# Access Compliance Report

## Public Rights-of-Way

Intersection ID: 3495	Main Street: MAPLE_VIEW_LN	Cross Street: W_W_T_HARRIS_BV	Location: SE
ADA ID: 6245A1AB3C8E	Ramp Type: Perp	Initial Pass/Fail: Fail	Overall Compliance: No
Severity Score: 21.25			
Codes/Mitigation Info/Possible Solution		Field Measurements/Component Compliance

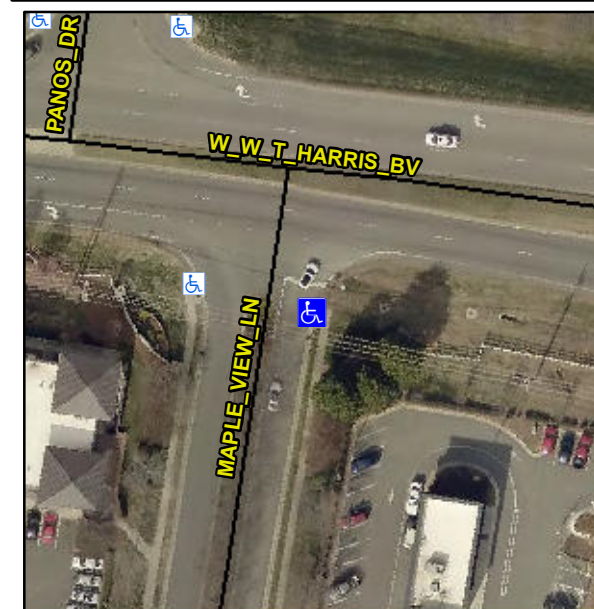
**Not Found, R304.5.1, R304.2.2**

Compliance	Description	Data	Compliance	Description	Data
N/A	Ramp Length (in)	47.0	No	Ramp Slope (%)	10.6
No	Ramp Width (in)	45.0	Yes	Ramp XSlope (%)	1.5
N/A	Flare Type LT	N/A	N/A	Flare Type RT	N/A
N/A	Flare Slope LT (%)	N/A	N/A	Flare Slope RT (%)	N/A
N/A	Flare Traversable LT?	N/A	N/A	Flare Traversable RT?	N/A
N/A	Landing Length (in)	N/A	N/A	DWS Provided?	N/A
N/A	Landing Width (in)	N/A	N/A	DWS Contrast?	N/A
N/A	Landing Slope (%)	N/A	N/A	DWS Length (in)	N/A
N/A	Landing X Slope (%)	N/A	N/A	DWS Full Width?	N/A
N/A	Landing Curb? (Y/N)	N/A	N/A	DWS Offset (in)	N/A
N/A	Shared Landing?	N/A			
N/A	Gutter Ponding?	N/A	N/A	Gutter Slope (%)	N/A
N/A	Gutter Lip Ht (in)	N/A	N/A	Gutter X Slope (%)	N/A
N/A	Painted X Walk1?	No	N/A	Painted X Walk2?	N/A
	X Walk 1 Direction	To W		X Walk 2 Direction	N/A
N/A	X Walk 1 Width (in)	N/A	N/A	X Walk 2 Width (in)	N/A
	X Walk 1 Slope (%)	0.9		X Walk 2 Slope (%)	N/A
	X Walk 1 X Slope (%)	3.6		X Walk 2 X Slope (%)	N/A

**Remove & Replace Entire Ramp.**
